**Modification in wire connection when using
PCBA-0335R6 to replace PCBA-0335R3**

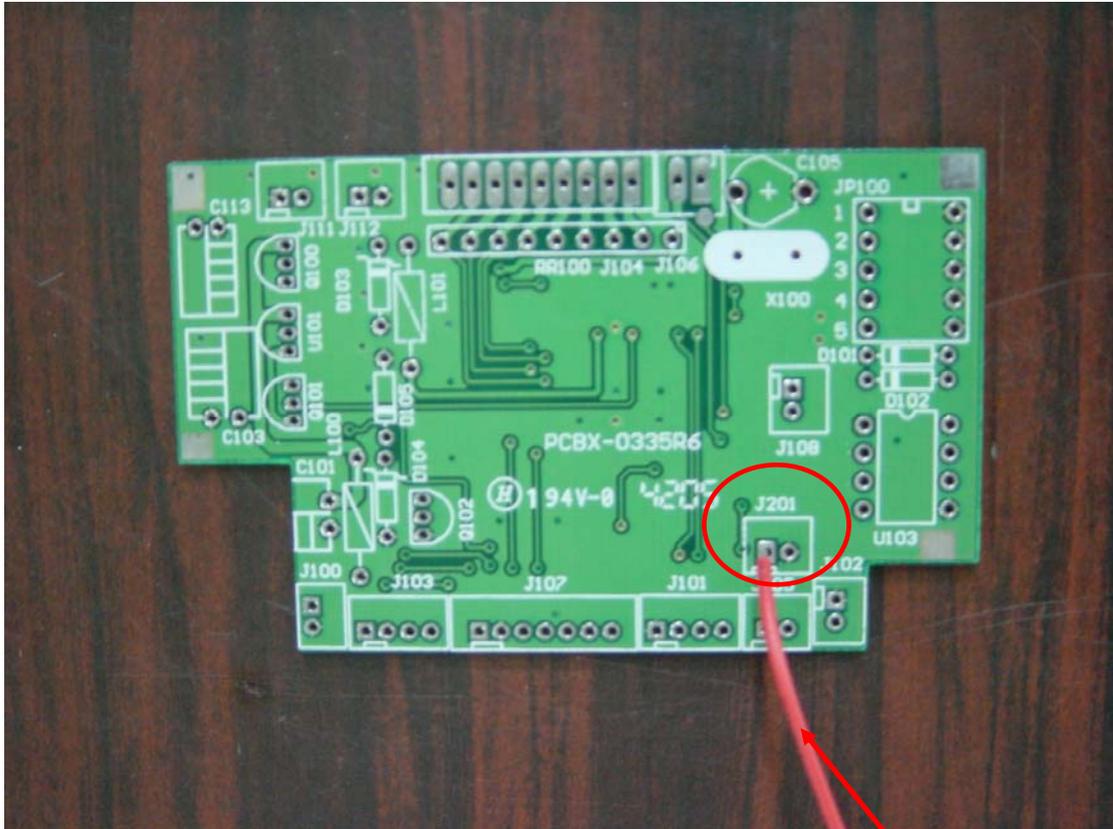
The red wire (which is originally connected to first lead of IC-358 of the module board mounted on PCBX-0335R3) is to be connected to the left hole of J-201 on the PCBX-0335R6.
